SAFETY ALERT SA0008

SUBJECT: Additional Electrical Protection

MODELS AFFECTED: CC11-100 and CC11-160 S/N 0001, 00002 through 00177.

Figure 2 - View from under looking up behind instrument panel

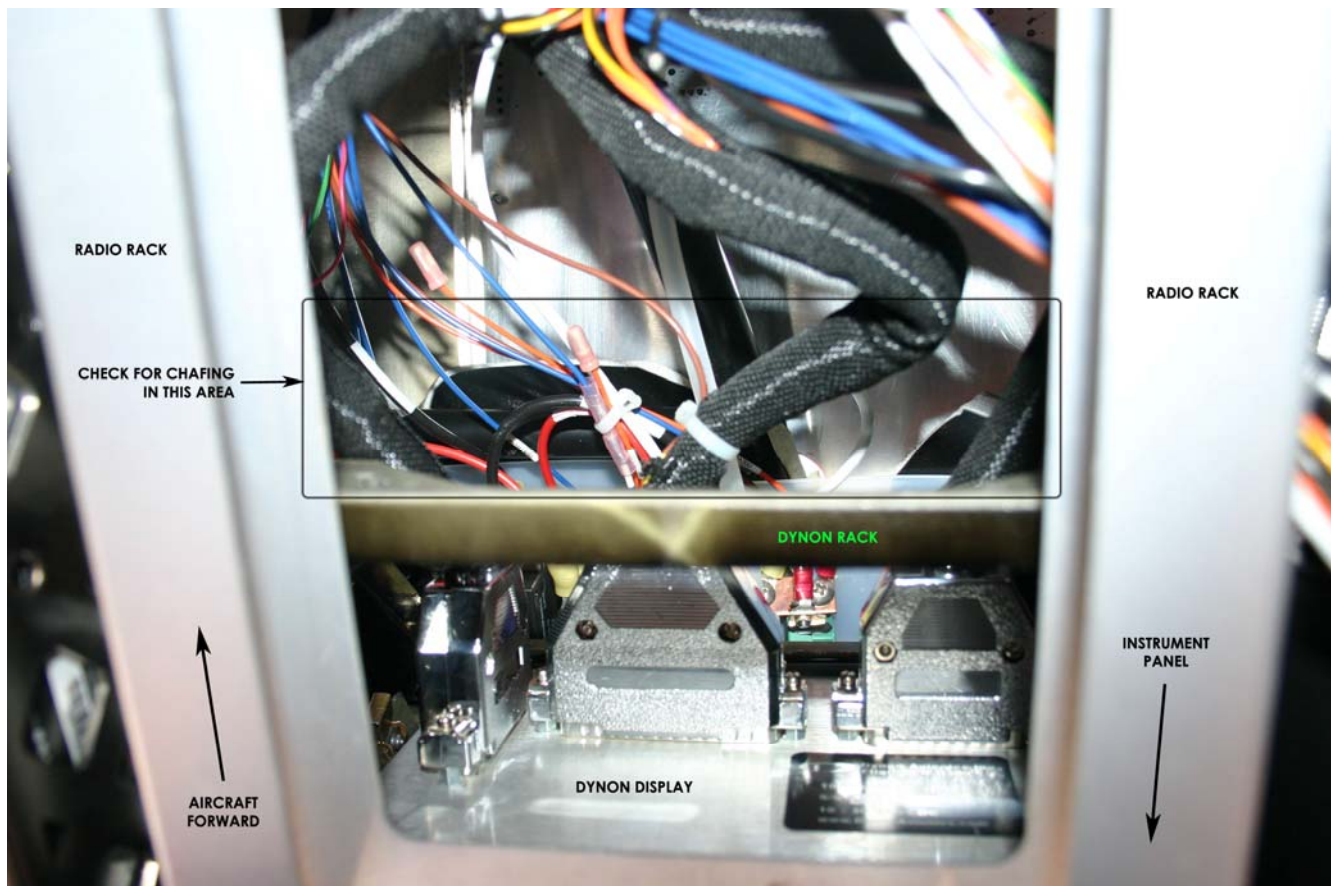
- v. Carefully inspect all wires, especially the ones that run from the circuit breakers and switches above the Dynon. Check for chaffing from contact with avionics or aircraft structure. (See Figure 2)

- b. Repair (if required).
 - i. If any wires are chaffed, repair per AC43.13 or AC65-15A. New jumpers may be fabricated using Mil-Spec 22759/16 (Tefzel) or equivalent wire. 12GA jumpers may be replaced with 10GA; 14GA or smaller may be repaired with a butt splice.
 - ii. If any wires are sagging and could possibly come into contact with the avionics, secure them in place.
- c. Installation of chafe protection.
 - i. Clean the upper part of the Dynon

Figure 5 - View looking up through access

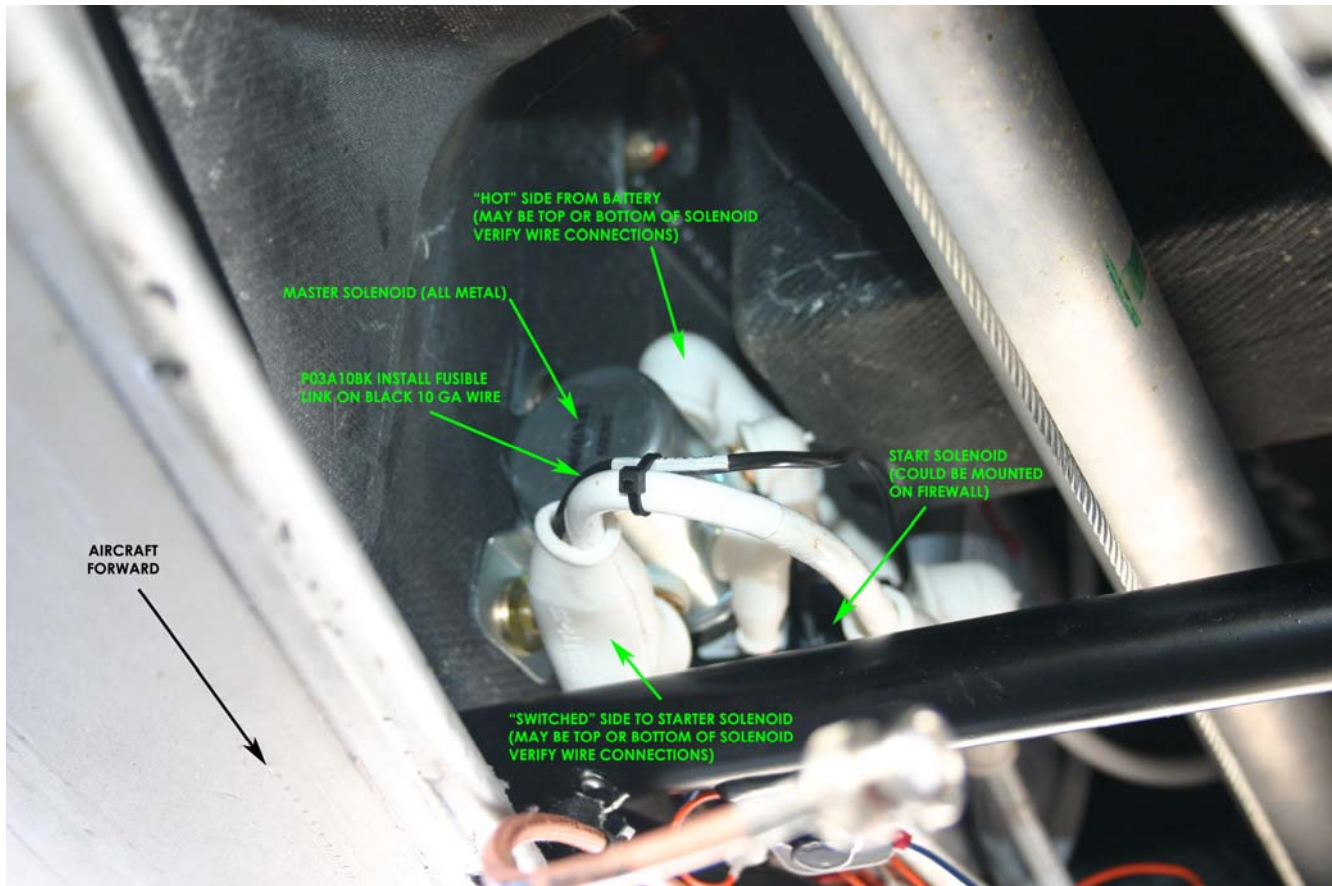
- b. Identify the black 10 GA wire attached to the Master Solenoid labeled: P03A10BK. (See Figure 5)

- i. Remove the ring terminal from the solenoid. Pull out the P03A10BK wire for proper fit and routing of a fusible link.
- ii. Clip off the existing ring terminal on P03A10BK

- iii. Crimp on the SC71021-001, Fusible Link, onto the P03A10BK wire per AC43.13 or AC65-15A. (See Figure 6)
